CAA Environmental Statement

Airspace Trial

Title of airspace change proposal	Reduced Night Noise Trial
Change sponsor	Gatwick Airport Limited
Project reference	ACP-2018-62
Account Manager	[REDACTED]

Figure 2: Arrivals heatmap for January – June 2023 between 0130 – 0500 (local time) representing traffic below 7,000 ft., overlaid with overflight cones of trial PBN arrival routes

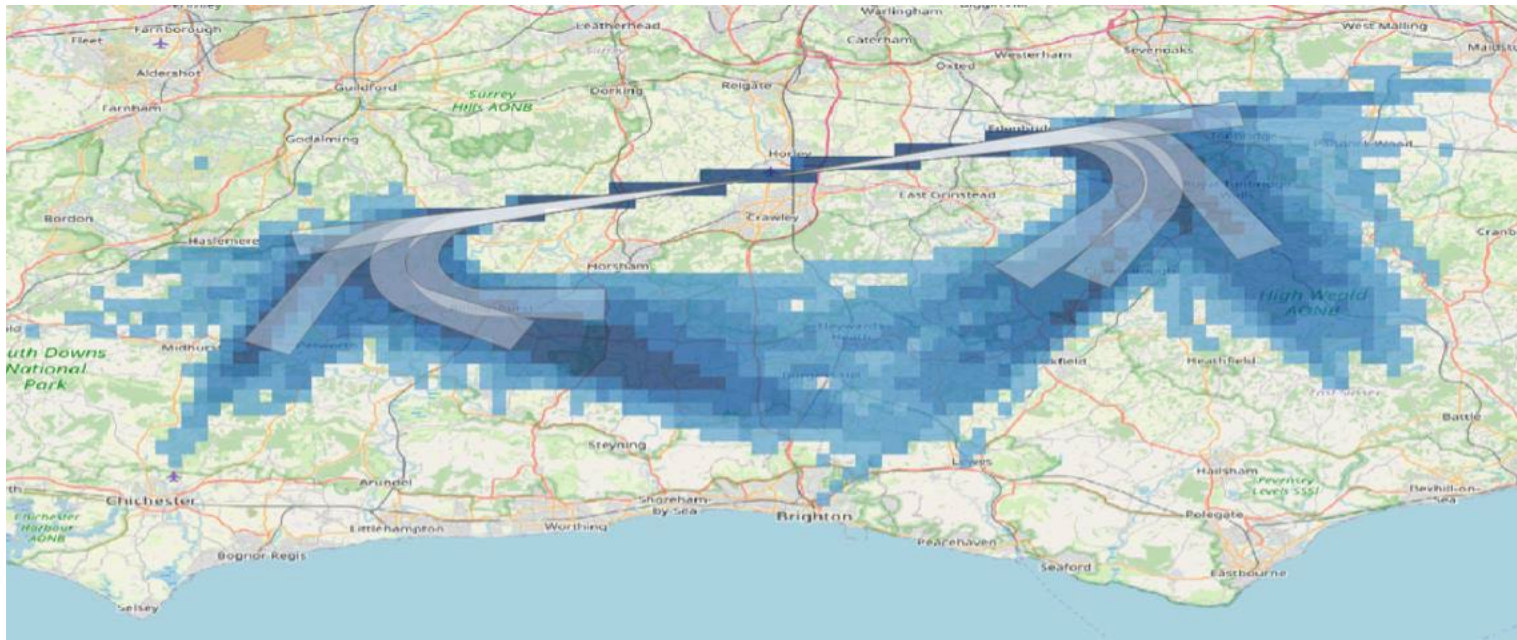
The sponsor has provided operational diagrams overlaid on maps to illustrate the current and estimated overflight of trial traffic upto 7,000 ft. The sponsor has presented radar data from January to June 2023 for night-time arrivals between 0130 and 0500 demonstrating existing flight patterns and their densities in a track density diagram. The trial PBN arrival procedures are located within the higher density regions of the existing arrival swathes so as to avoid overflight of any new communities while minimising concentration and dispersing arrivals. A total of 8 PBN arrival procedures have been designed - 4 to each end of the airport's southern runway.

The sponsor states that the historic shape of the arrival traffic swathes into the airport has remained unchanged since 2017, when the trial PBN arrival procedures were first designed. Updates to the design or location of these routes is therefore not necessary. The CAA agrees with this reasoning as the 2023 arrival swathes are largely coincident with those in 2023 and the proposed trial PBN arrival procedures are coincident with this area already overflown during the trial timings.

Figure 6 (left): Vertical profile of A320 arrivals (outlier in green, trial like in purple and hypothetical trial in yellow)

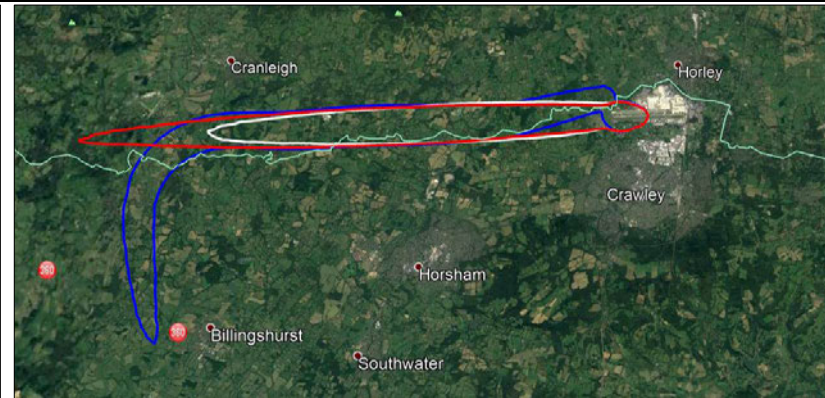
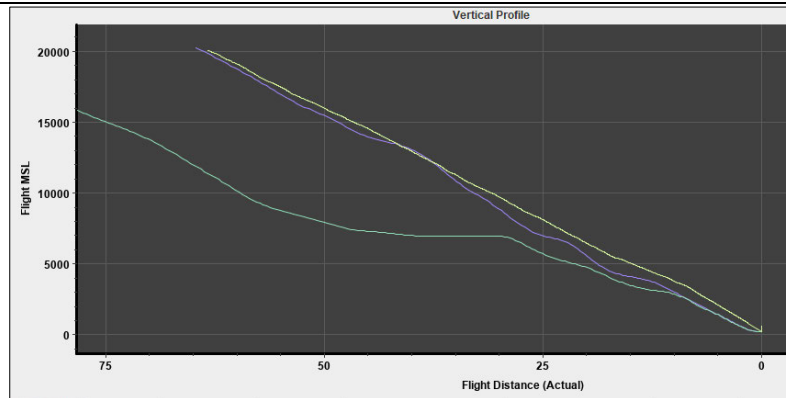
The sponsor has assessed the loudest and most frequent types of aircraft that will be participating in the trial. The most frequent aircraft are A320, A321 and B737 while the loudest aircraft are B777, A330 and B787. The sponsor has presented 60 dB L_{max} footprints using the Federal Aviation Administration's (FAA) Aviation Environmental Design Tool (AEDT) and Volans to create the standard vertical profile of the trial procedure. The footprints have been presented for: • An 'outlier' arrival (an actual, recorded arrival) flying an unduly noisier or lower profile than other aircraft • A 'trial like' arrival (an actual, recorded arrival) flying a similar profile to a trial aircraft • An expected arrival of a hypothetical trial arrival Six comparisons were made for A320, B787-9, B737-800 with winglets and B767 flying to different runways. An extract is presented below, and more details can be found in Annex L of the sponsor's submission.

The sponsor has not presented 60 dB LMax footprints for each of the trial PBN arrival procedures, nor presented a robust rationale with appropriate supporting evidence as justification where footprints are anticipated to be similar between the trial PBN arrival procedures (e.g., in terms of areas and locations). The noise footprints are also required to identify any communities that may be affected by the trial. However, the sponsor states that extensive engagement has already been undertaken through the Gatwick Airport Noise Management Board (NMB), including for communities in all areas under the proposed trial routes. It is therefore considered that this requirement is partially met.

It is also important to note that the noise modelling performed does not comply with CAP 2091, CAA Policy on Minimum Standards for Noise Modelling Category A standards which apply to Gatwick Airport.
